UNITED STATES PATENT AND TRADEMARK OFFICE

APPLICATION NO.	FILING DATE	FIRST NAMED INVENTOR	ATTORNEY DOCKET NO.	CONFIRMATION NO.
08/811,152	03/04/1997	YOSHIHARU HIRAKATA	07977/132001	9805

Office Action Summary

DETAILED ACTION

Figure 4A

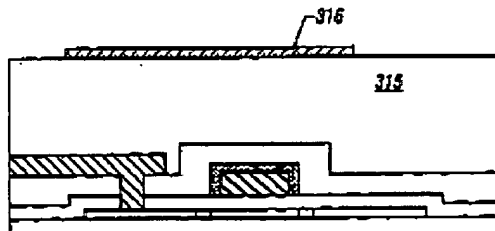
4. Yamazaki discloses and shows in Figs. 3A and 4A-4B, a liquid crystal display device (col. 1, line 6) comprising:

- a second interlayer insulating film (315) (applicant's first interlayer insulating film) comprising an organic resin over the thin film transistor;
 - a common electrode (316) having a function of black matrix over the first insulating film (315);
 - a third interlayer insulating film (317) (applicant's second interlayer insulating film) over the common electrode (316);
 - a pixel line and at least one pixel electrode both formed over the second interlayer insulating film (317), the pixel electrode extending from the pixel line;
 - a liquid crystal layer over the pixel line and the pixel electrode;
- wherein the pixel electrode is electrically connected to the thin film transistor through the pixel line; and
- a storage capacitor (319) formed between the pixel line and the black matrix.

Yamazaki differs from the claimed invention because Yamazaki does not explicitly disclose that the liquid crystal display device is an in-plane switching type device, i.e., the liquid crystal layer being driven by an electric field formed between the pixel electrode and the common electrode, the electric field having a component parallel with the substrate.

Figure 4B

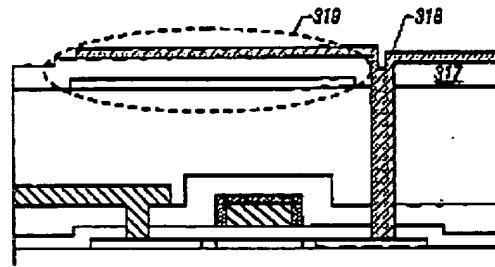
As to claims 145, 152 and 159, it is clear from figure 4B of Yamazaki that the second interlayer insulating film (315) (applicant's first interlayer insulating film) exhibits excellent flatness and thus serves as a planarization film.

6. Yamazaki discloses a liquid crystal display device comprising a thin film transistor connected with the pixel electrode and having, as an active layer, a semiconductor layer. See Fig. 4B.

As to claim 165, it is clear from figure 4B of Yamazaki that the second interlayer insulating film (315) (applicant's first interlayer insulating film) exhibits excellent flatness and thus serves as a planarization film.

10. Yamazaki discloses a liquid crystal display device comprising a thin film transistor connected with the pixel electrode and having, as an active layer, a semiconductor layer. See Fig. 4B.
